SUBJECT: FINAL SAFETY EVALUATION OF THE BWRVIP-234: THERMAL AGING AND  
NEUTRON EMBRITTLEMENT EVALUATION OF CAST AUSTENITIC  
STAINLESS STEEL FOR BWR INTERNALS (TAC NO. ME5060)

## **SAFETY EVALUATION OF THE BWRVIP-234 REPORT**

### **FOR BWR INTERNALS (BWRVIP-234)”**

Figure 1. Plot of predicted toughness (J-integral value at 2.5 mm crack extension) from BWRVIP-100-A and NUREG/CR-6960 as a function of neutron fluence. The predicted lower-bound toughness of CF-8 due to TE alone is shown at the bottom of the vertical line at dpa = 0 for reference.

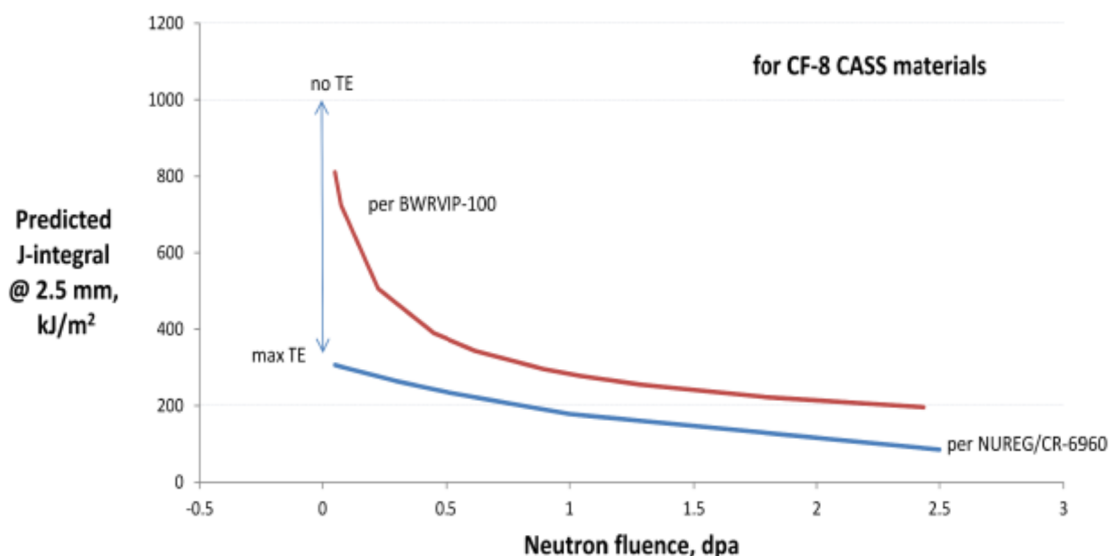
The other method used in the TR to validate the toughness basis for the screening criteria is the BWRVIP-100-A lower bound curve. To determine whether the use of the BWRVIP-100-A model was appropriate for CASS, the NRC staff compared the prediction methodology for fracture toughness from BWRVIP-100-A to that of NUREG/CR-4513, Rev. 1 (Ref. 11) and NUREG/CR-6960 (Ref. 12). The comparison for  $J @ 2.5$  is shown in Figure 1 along with the range of predicted J values for unirradiated CF-8 with no thermal embrittlement (TE) and maximum TE (no irradiation) for CF-8 with > 15 percent delta ferrite (Section 3.1.1 of Ref. 11) along with the Ref. 12 predicted toughness trend as a function of fluence. The lower-bound from Ref. 12 is lower, and therefore more conservative than the BWRVIP-100-A predicted toughness. The predicted toughness from Ref. 12 at 0 dpa (no irradiation) is also consistent with the minimum predicted toughness for CF-8 material due to TE alone, represented by the bottom of the vertical line at dpa = 0 on Figure 1. If extrapolated beyond where it was intended to be used, BWRVIP-100-A would predict a much higher toughness at 0 dpa. Based on this comparison, the NRC staff determined that the BWRVIP-100-A methodology maybe be an effective way to account for IE in welded, wrought structures like the core shroud, but the predicted toughness does not consider the effect of TE and therefore would not be a suitable methodology to use in the TR to account for the combined effects of TE + IE on CF-3 and CF-8 materials, especially those with greater than 15 percent but less than 20 percent ferrite (these would pass the screening for TE alone in the Grimes letter).

Figure A1. Plot of predicted lower-bound  $J @ 2.5 \text{ mm}$  (BWRVIP-100 and NRC staff proposed) vs. neutron fluence. Arrow reflects shift of BWRVIP-100 curve to the left, represents assumed contribution to lower-bound  $J @ 2.5 \text{ mm}$  due to IE.

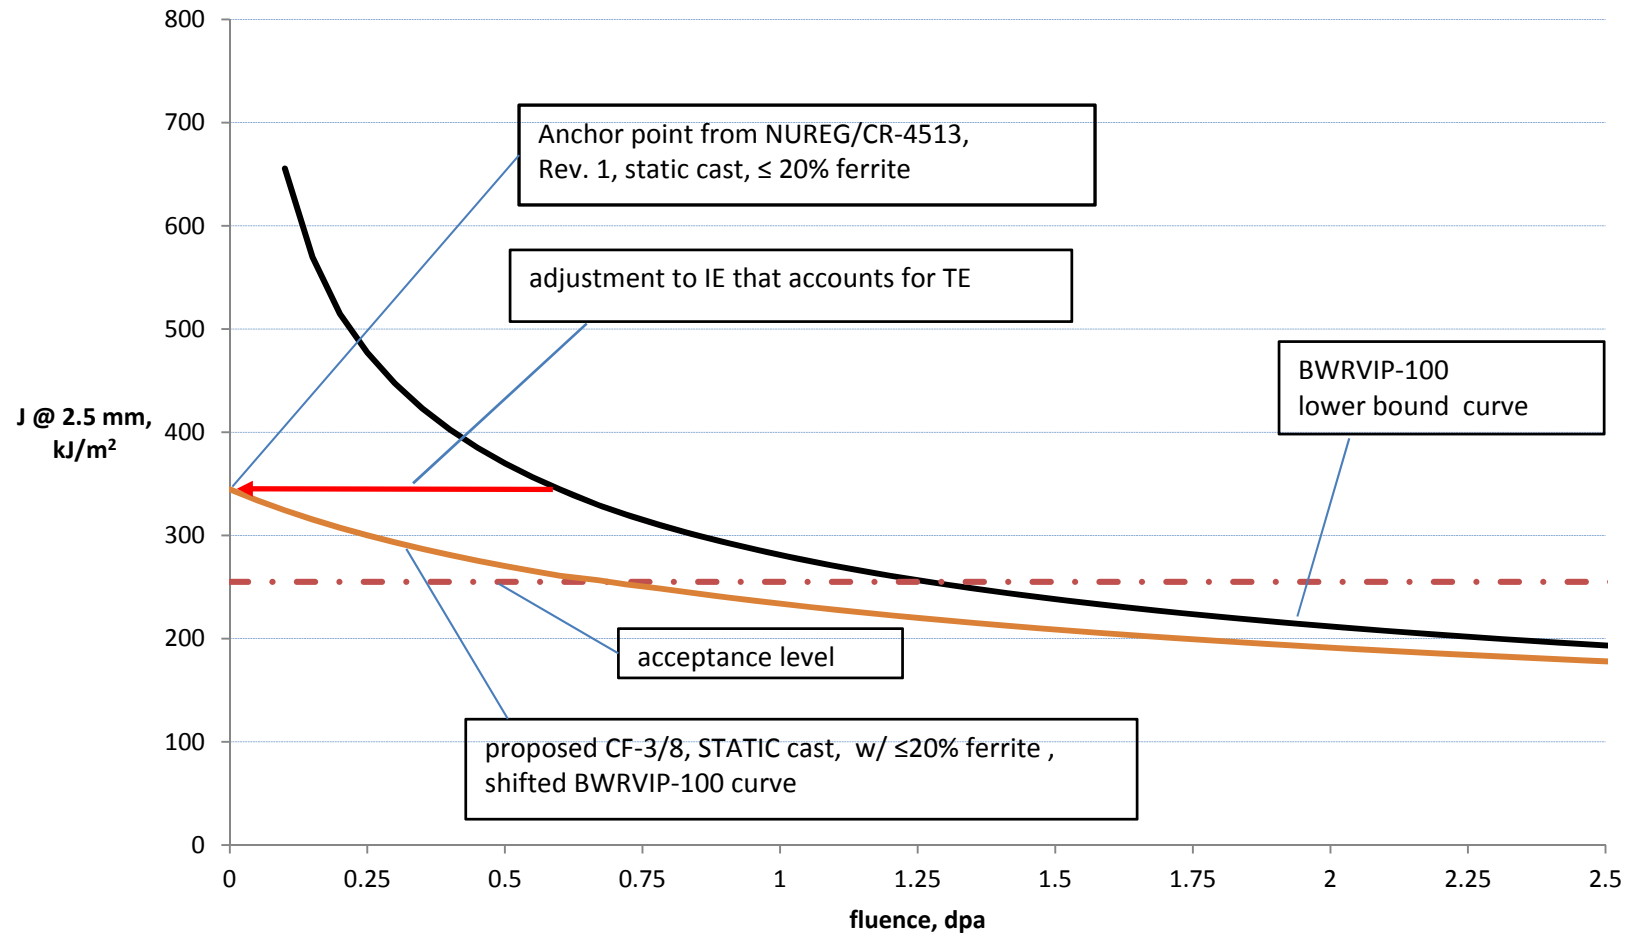
5	Second page of Appendix A, Figure A1	Accuracy	The "< 20 % ferrite" values in Figure A1 need to be changed to "≤ 20% ferrite" to be consistent with Table A1.	Agreed
6	Headers throughout	Clarification	As the SE does not contain any EPRI proprietary information, "Proprietary Information" can be removed from the headers.	Agreed
